Access Compliance Report Public Rights-of-Way (Curb Ramps)

Main Street: CHESNEY_DR Cross Street: WEMBLEY_RD Location: N

ADA ID: RPAT211201090505 Ramp Type: Type 1 - Perpendicular Diagonal Initial Pass/Fail: Pass Overall Compliance: No Severity Score: 14

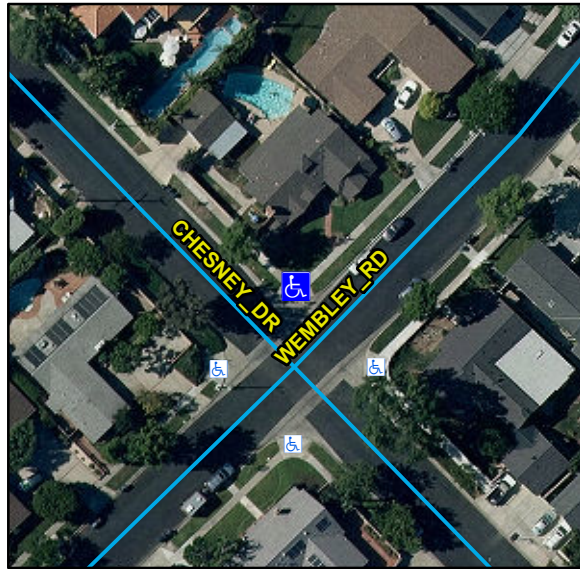
R204.3, R304.2.1, R304.2.2-Perp, R304.3.2-Para, R305, STD 1115

Remove & Replace Curb Ramp With Two New Directional Ramps or Equivalent.
